# MMA Technical Standards Board/ AMEI MIDI Committee

Confirmation of Approval for MIDI Standard

(CA-033) MIDI 1.0 Electrical Specification Update [2014]

This document updates the MIDI 1.0 Electrical Specification to include 3.3-volt signaling and optional RF grounding. This document replaces the *Hardware* section of the *MIDI 1.0 Detailed Specification (Document Version 4.2)*, which is included in the MMA publication "The Complete MIDI 1.0 Detailed Specification".

Figure 1 – MIDI OUT Circuit

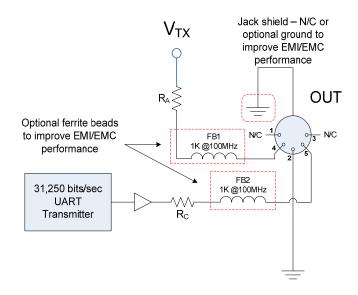
Pin 2 must be tied to ground on the MIDI transmitter only.

The buffer between the UART transmitter and  $R_{\rm C}$  is optional and system-dependent.

The optional ferrite beads are 1k-ohm at 100MHz such as MMZ1608Y102BT or similar.

$V_{TX}$	+5V ± 10%	+3.3V ± 5%
R <sub>A</sub>	220Ω 5% 0.25W	33Ω 5% 0.5W
R <sub>C</sub>	220Ω 5% 0.25W	10Ω 5% 0.25W

The buffer shown in the MIDI Out circuit driving  $R_C$  is optional and system-dependent, and if present, may be implemented as an IC gate or transistor or a combination.

The MIDI current loop can run at low-voltage (3.3V) signal levels. The MIDI output circuit is the only affected component for Low-Voltage Signaling. It requires changing the output resistors from  $220\Omega$  to  $33\Omega$  and  $10\Omega$  ( $\pm 5\%$ ) and changing the voltage from +5V to +3.3V ( $\pm 5\%$ ).

The schematic diagram in Figure 1, above, supports either +5V or +3.3V signaling.

It is required to have short-circuit current-limiting on the MIDI Output as well, which is achieved by series resistors on each of the two output pins. The series resistors are also subject to the IR voltage drop introduced by the 5 mA current, thus increasing the minimum transmitter voltage. The logical choice is +3.3V as a minimum transmitter voltage. The series resistor values should satisfy the following relationship:

$$(R_A + R_C) = (V_{TX} - V_{RXDROP}) / .005$$

Substituting +3.135V (95% of +3.3V) for  $V_{TX}$  and solving for  $(R_A + R_C)$ , this reduces to:

$$(R_A + R_C) = 27\Omega$$

The recommended values of  $33\Omega$  and  $10\Omega$  for  $R_A$  and  $R_C$  produce a total resistance of  $43\Omega$ , which reduces the worst-case current to 4.472 mA, assuming a -5% power supply, +5% resistors, and a forward drop of 1.9V. It is not clear, however, that 1.9V can be achieved with only 4.472 mA drive, as the maximum forward drop occurs at the highest current. If the forward drop decreases, the current through the resistors increases.

This requires using a 0.5W resistor or additional current-limiting circuitry. The  $R_A$  resistor is pulling straight up to a 3.3V power supply, so the 0.5W rating is necessary. It is, of course, acceptable to use parallel resistors to achieve a higher power rating. For example, one could use four 0.125W 130 $\Omega$  resistors in parallel, producing an equivalent resistance of 32.5 $\Omega$  and power rating of 0.5W.

It is assumed that the digital buffer driving R<sub>C</sub> in 3.3V designs is open collector or open drain, which allows a smaller 0.25W resistor to be used with adequate protection in the event of a MIDI cable short-circuit. Care must be taken when using digital buffers in 3.3V designs to not exceed the buffer's maximum short-circuit current in the event of a MIDI cable short-circuit.

Figure 2 - MIDI IN and THRU circuit

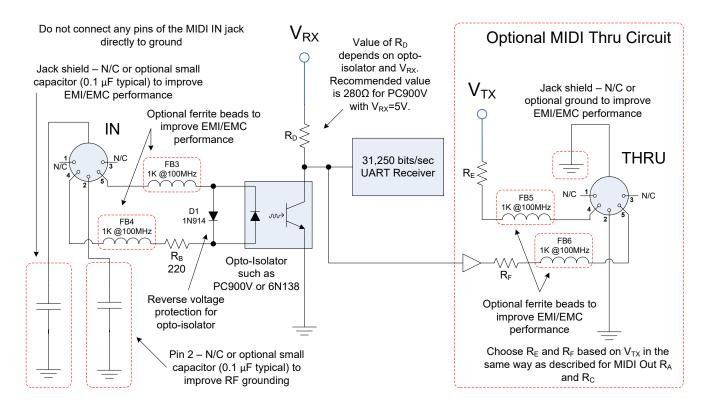
Pin 2 of the MIDI In connector shall not have any DC path to the receiver's ground. However, a connection through a small capacitor  $(0.1\mu F$  typical) to ground is optional for improved high-frequency (RF) shielding.

The shield connector of the MIDI In jack shall not have any DC path to the receiver's ground. However, a connection through a small capacitor ( $0.1\mu F$  typical) to ground is optional for improved EMI/EMC performance.

The MIDI input circuit is specified to operate with no connection to ground, in order to avoid ground loops. This is good for audio-frequency signals. However, the cable inductance raises the impedance at high (RF) frequencies making the transmitter ground less effective at longer cable lengths. One solution to this is to connect Pin 2 of the MIDI In jack to ground through a small capacitor. The small capacitor provides a low-impedance path to ground for high (RF) frequencies at the MIDI Receiver side while maintaining immunity to audio-frequency ground loops. A capacitor value of  $0.1\mu F$  is optionally recommended, which results in an impedance of  $0.16\Omega^3$  at 10 MHz; practically a dead short. At 20 kHz the impedance is  $79.6\Omega$ , and at 60 Hz the impedance is  $26.5 \text{k}\Omega$ .

The schematic in Figure 2 (above) illustrates the use of the optional RF grounding capacitor.

The optional ferrite beads FB1-6 shown in Figures 1-2 attenuate RF interference by presenting an impedance of  $1k\Omega$  at 100MHz while having a DC resistance of near zero. Although an example component (MMZ1608Y102BT) is designated, different components may be substituted to tune the impedance characteristic to the specific product design. The ferrite beads are optional and are not required for proper MIDI functionality. They may be omitted if the product does not need them to comply with EMC regulations.

If present, the ferrite beads should be placed as close to the jacks as possible. The schematics in Figure 1 and Figure 2 (above) illustrate the use of the optional ferrite beads.

However, to improve EMI/EMC performance, it is now permitted, as an option, to connect the grounding shield connectors on MIDI Out and MIDI Thru jacks to ground. It is also permitted, as an option, to connect the grounding shield connector of a MIDI In jack to a small capacitor to ground  $(0.1\mu F$  typical), in order to avoid a ground loop when an improperly wired MIDI cable is connected. But it is still not permitted to connect the grounding shield connector of a MIDI in jack directly to ground.
